**PROPOSAL:**

Kevin Rhinehart requests a certificate of appropriateness for work at 1717 D Street, the Myron Wheeler House, a designated landmark.

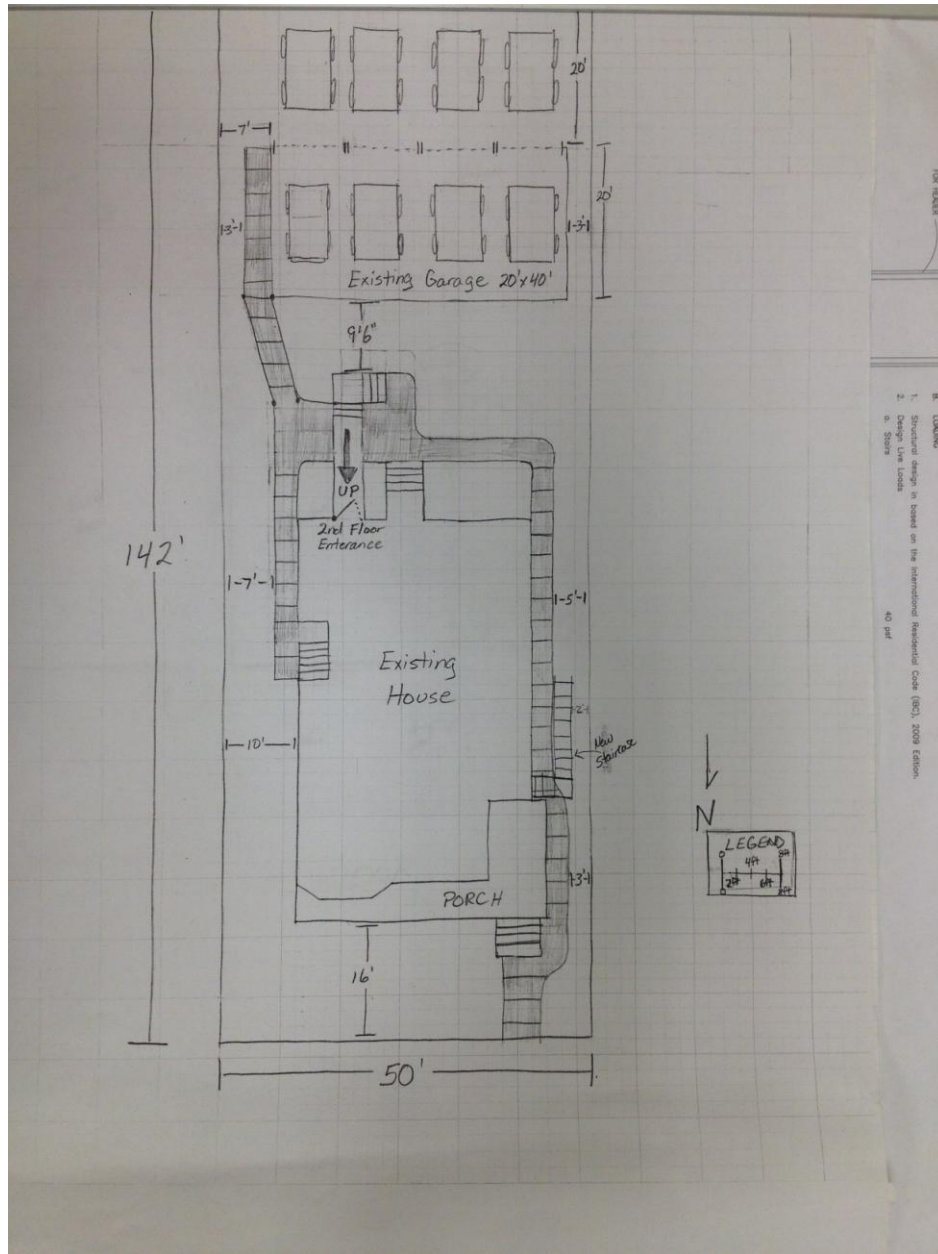
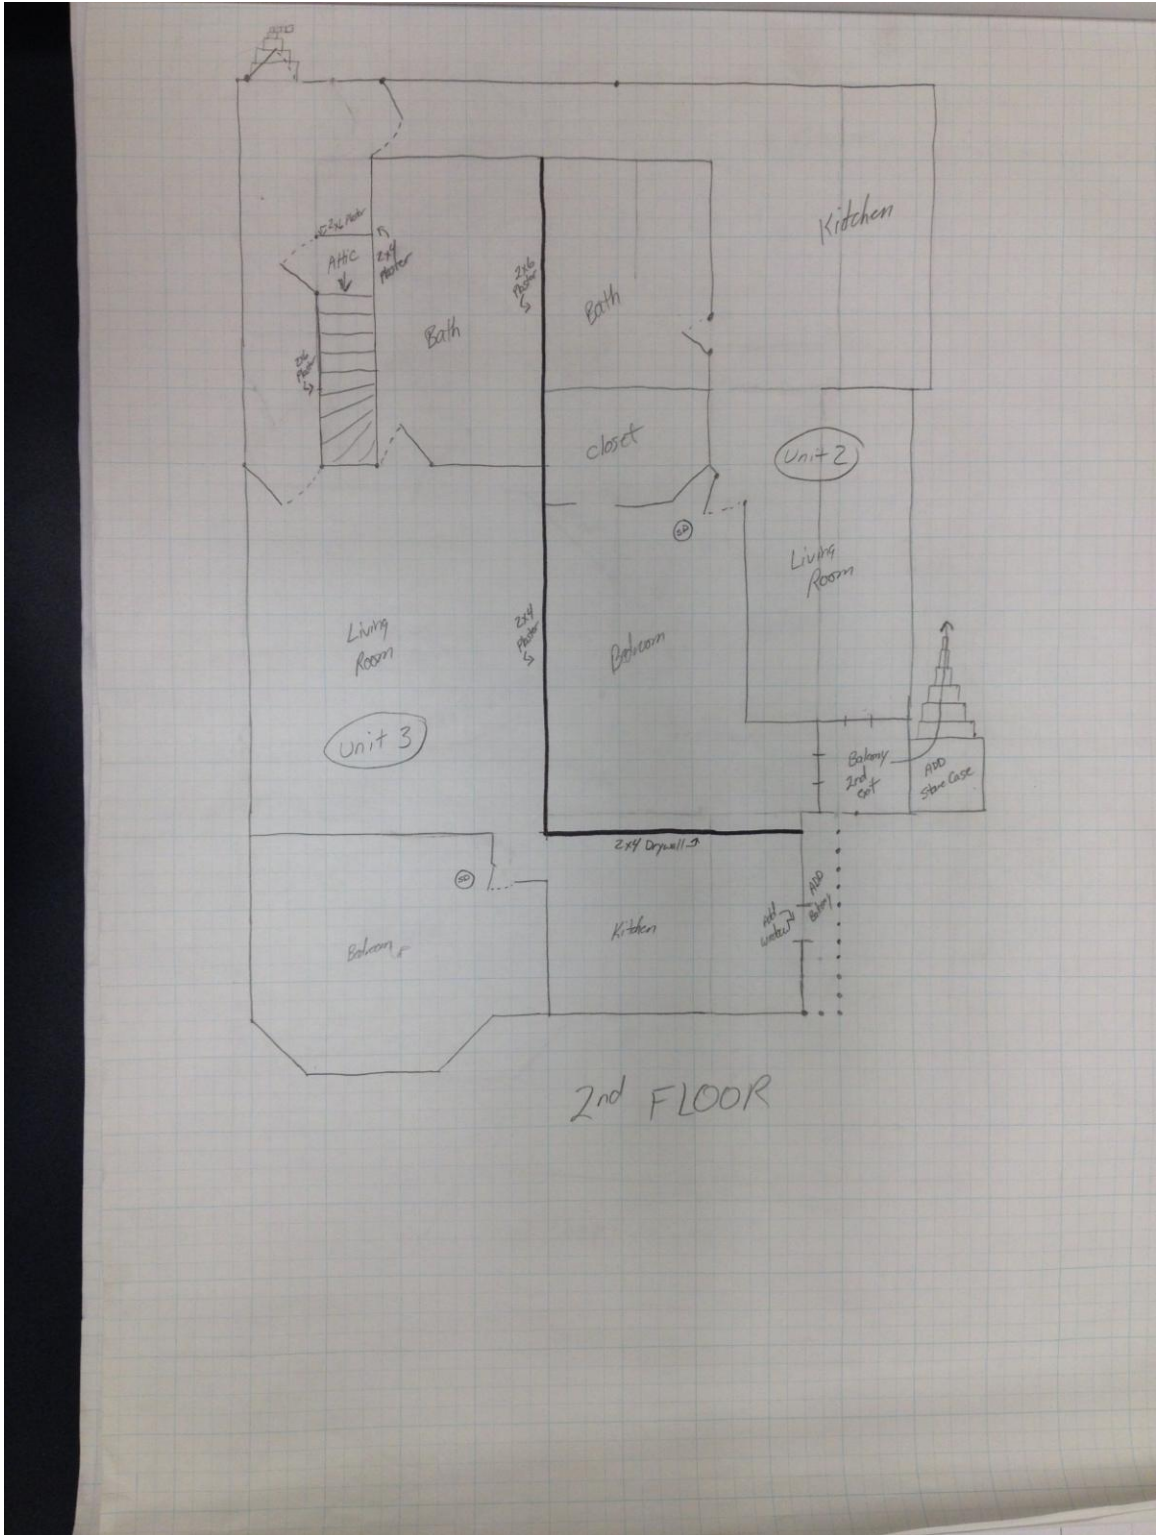
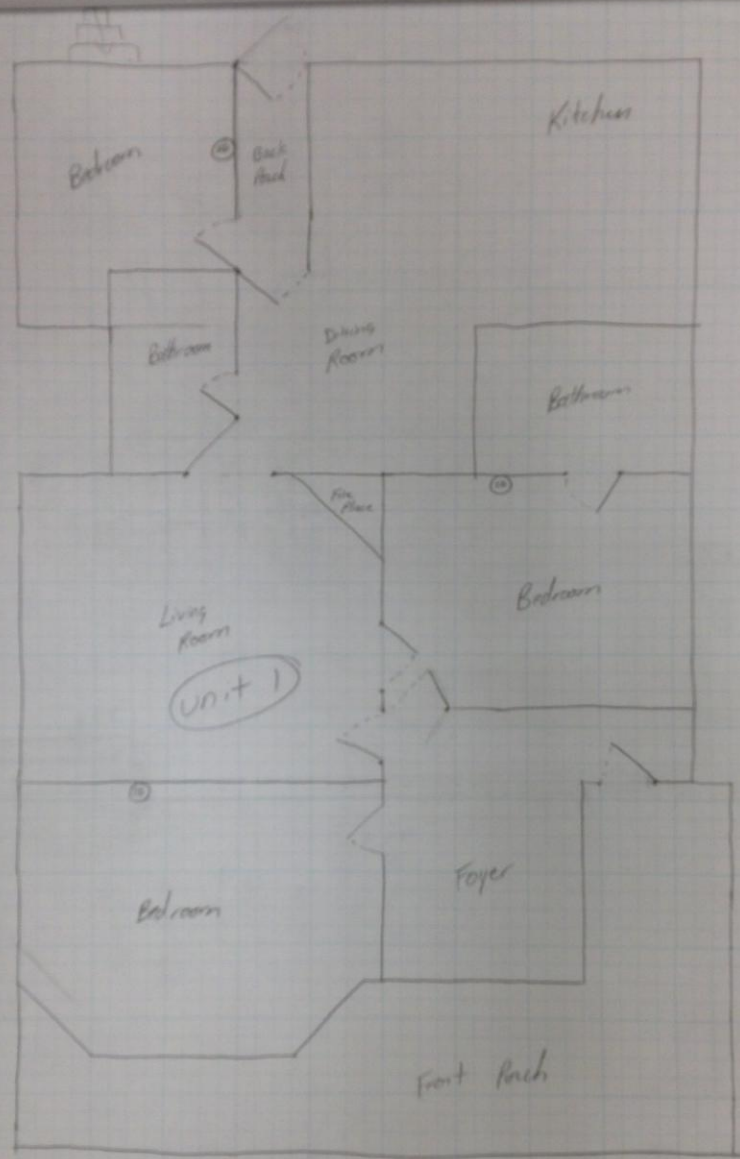
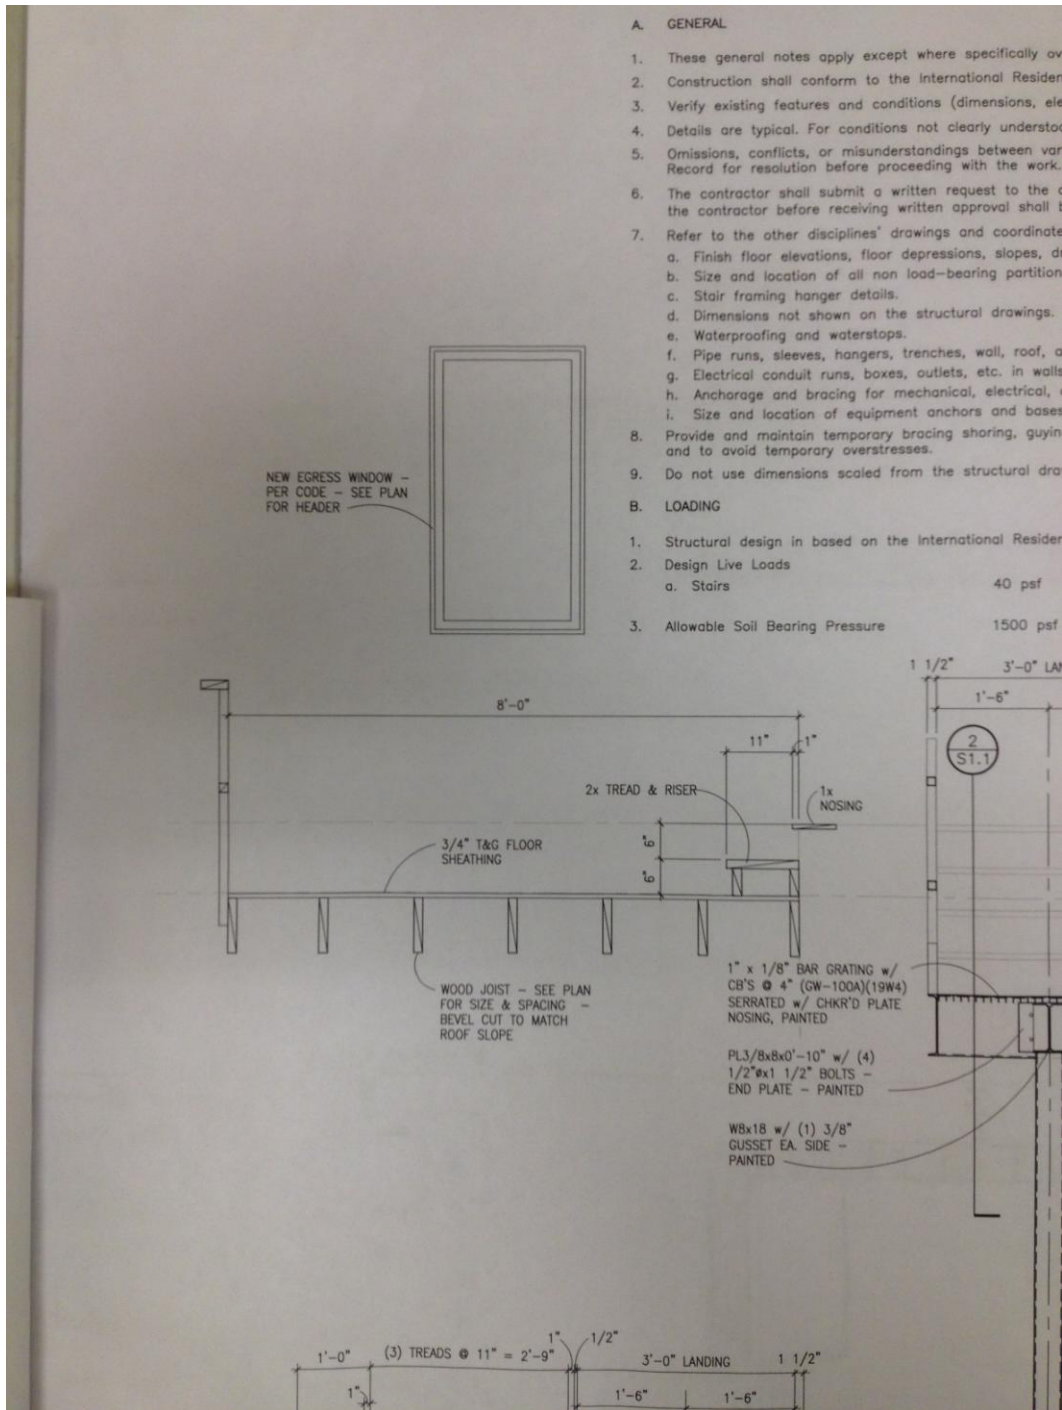
To complete that work, Mr. Rhinehart has requested to add a second egress route for the second floor units. (See attached plans.) The proposal is to add a window to the west wall above the front porch, accessing a wooden balcony to be added above the porch roof, connecting to the small upper porch inset at the northwest corner of the house. That porch would be modified to access a steel staircase extending down (towards the south) 23' along the west side of the house. The staircase would be 2'9" away from the west wall and approximately two feet from the west property line.

This modification would be highly visible from D Street and the public sidewalk. It would insert a window into the field of decorative shingles on the west wall and would require modification of both the north and west walls of the small upper porch.

The proposals do not meet the guidelines. Staff recommends that a certificate of appropriateness not be approved.

*Denial of a certificate of appropriateness.*
